Access Compliance Report

Public Rights-of-Way

Intersection ID: 10143	Main Street: E_34TH_ST	Cross Street: N_DAVIDSON_ST	Location: SE
ADA ID: C52048CF54AA	Ramp Type: Perp	Initial Pass/Fail: Fail	Overall Compliance: No
Severity Score: 21.25			
Codes/Mitigation Info/Possible Solution		Field Measurements/Component Compliance

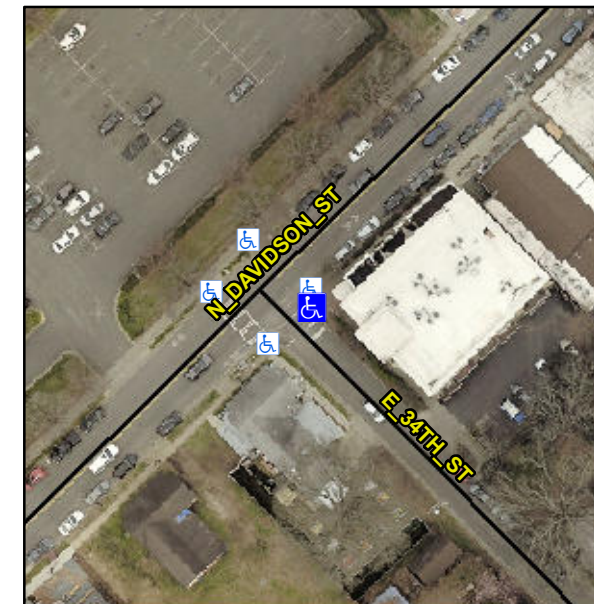
Not Found, R304.5.1, R304.2.2

Compliance	Description	Data	Compliance	Description	Data
N/A	Ramp Length (in)	68.5	No	Ramp Slope (%)	9.3
No	Ramp Width (in)	46.0	Yes	Ramp XSlope (%)	0.1
N/A	Flare Type LT	N/A	N/A	Flare Type RT	N/A
N/A	Flare Slope LT (%)	N/A	N/A	Flare Slope RT (%)	N/A
N/A	Flare Traversable LT?	N/A	N/A	Flare Traversable RT?	N/A
N/A	Landing Length (in)	N/A	N/A	DWS Provided?	N/A
N/A	Landing Width (in)	N/A	N/A	DWS Contrast?	N/A
N/A	Landing Slope (%)	N/A	N/A	DWS Length (in)	N/A
N/A	Landing X Slope (%)	N/A	N/A	DWS Full Width?	N/A
N/A	Landing Curb? (Y/N)	N/A	N/A	DWS Offset (in)	N/A
N/A	Shared Landing?	N/A			
N/A	Gutter Ponding?	N/A	N/A	Gutter Slope (%)	N/A
N/A	Gutter Lip Ht (in)	N/A	N/A	Gutter X Slope (%)	N/A
N/A	Painted X Walk1?	Yes	N/A	Painted X Walk2?	N/A
	X Walk 1 Direction	To SW		X Walk 2 Direction	N/A
N/A	X Walk 1 Width (in)	108.0	N/A	X Walk 2 Width (in)	N/A
	X Walk 1 Slope (%)	3.8		X Walk 2 Slope (%)	N/A
	X Walk 1 X Slope (%)	0.6		X Walk 2 X Slope (%)	N/A

Remove & Replace Entire Ramp.
